UNITED STATES
NUCLEAR REGULATORY COMMISSION
WASHINGTON, D. C. 20555

May 15, 1984

OCONEE NUCLEAR STATION, UNIT NO. 2

Amendment No. 129
License No. DPR-47

CORE PROTECTION
SAFETY LIMITS
UNIT 3
OCONEE NUCLEAR STATION
Figure 2.1-2C

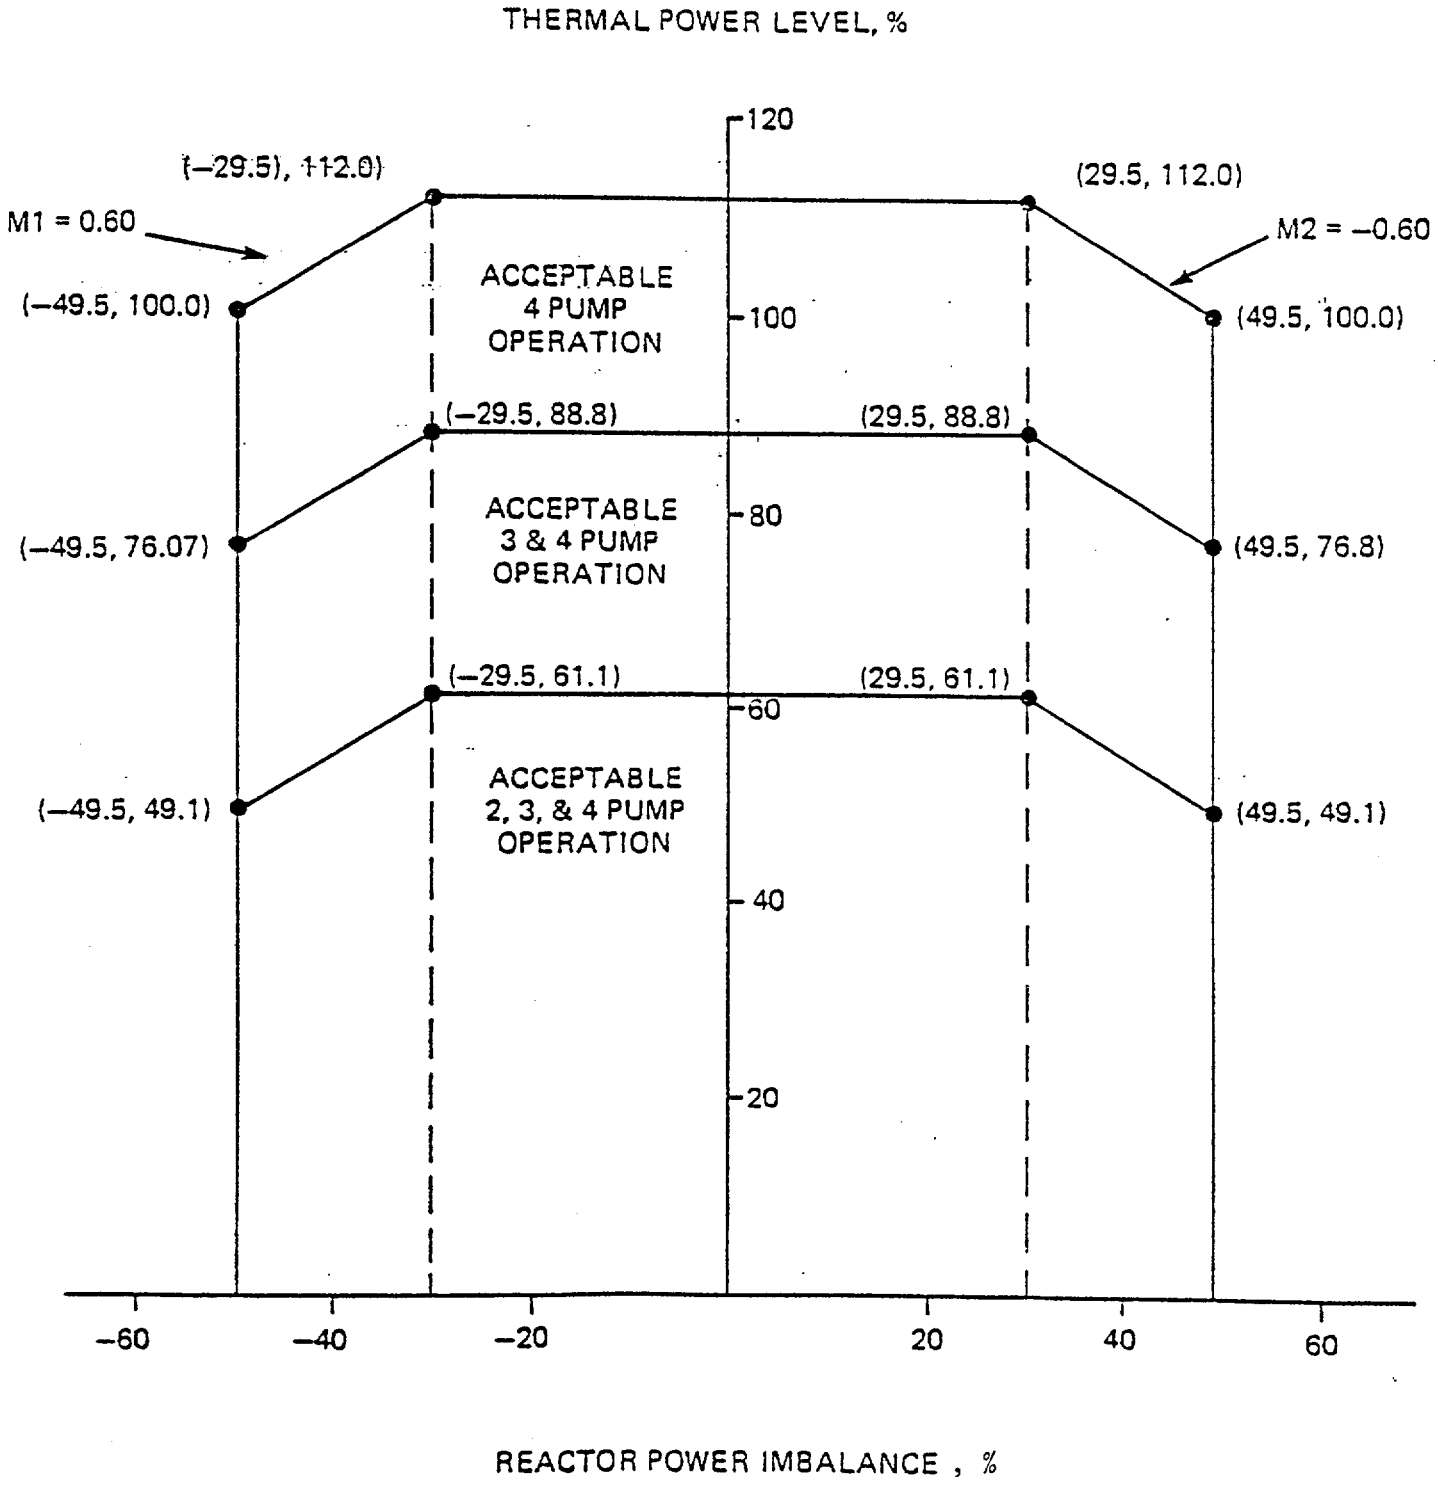
Oconee Unit 3 Cycle 8 Technical Specifications have been modified to account for (i) minor changes in power peaking and control rod worths during Cycle 8 operation, (ii) incorporation of NUREG-0630 data (Ref. 17) in the LOCA analysis and (iii) employment of a Monte Carlo simulation technique in determining instrument string errors (Refs. 18 and 11). We have reviewed the proposed Specification revisions for Cycle 8. These changes concern the (1) Core Protection Safety Limits of Specification 2.1, (2) Protective System Maximum Allowable Setpoints of Specification 2.3 and (3) Rod Position Limits of

Specification 3.5.2. The limiting safety system settings and the limiting conditions for operation have been established by approved methods. Changes which reflect the core thermal-hydraulic response continue to maintain the safety limit DNBR criterion of 1.30. The control rod withdrawal limits for the various pump combinations and times in core life are presented as well as part length axial power shaping rod position limits. On the basis that previously approved methods were used to obtain the limits, we find these Technical Specification modifications acceptable.
